PETITION NO. 1220 - Windham Solar LLC Declaratory Ruling that no Certificate of Environmental Compatibility and Public Need is required for the proposed construction, maintenance and operation of three 2.0 Megawatt and one 1.0 Megawatt Solar Photovoltaic Electric Generating facilities located at 1219 and 1240 Voluntown Road, Griswold, Connecticut. **Partial Development and Mangement Plan-Site Clearing Request.**

Petition No. 1220
Windham Solar LLC
D&M Plan – Site Clearing
1219 and 1240 Voluntown Road, Griswold
Staff Report
August 30, 2018

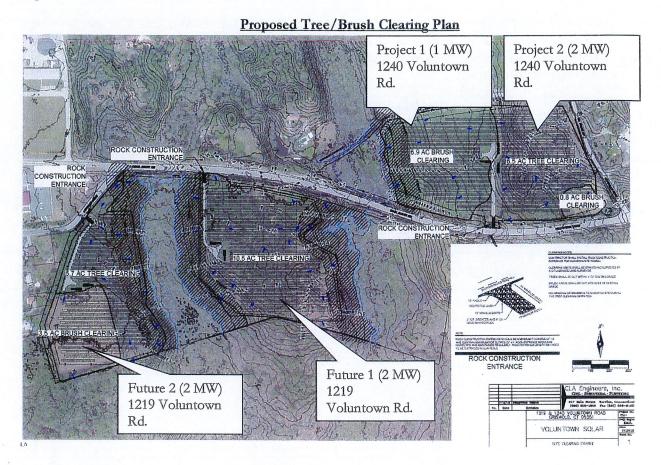
The Site Clearing Request contains three tree clearing areas and three brush clearing areas to accommodate all four arrays. One 6.9-acre brush clearing area would be located in the vicinity of Project 1. One 6.5-acre tree clearing area and one 0.8-acre brush clearing area would be located in the vicinity of Project 2. One 10.5-acre tree clearing area would be located in the vicinity of Future 1. One 5.7-acre tree clearing area and one 3.5-acre brush clearing area would be located in the vicinity of Future 2. See attached figure titled, "Proposed Tree/Brush Clearing Plan."

3 MW interconnection. Council staff suggests including a condition that the tree/brush clearing be limited only to the 1240 Voluntown Road site at this time, and that the plans for tree/brush clearing for the 1219 Voluntown Road site be submitted in the future when the interconnection limitation concerns are resolved and/or mitigating plans such as battery storage/tracking panels are firm.

1. This approval is limited to the tree and brush clearing (and rock construction entrance work) on the eastern parcel (i.e. 1240 Voluntown Road) only;
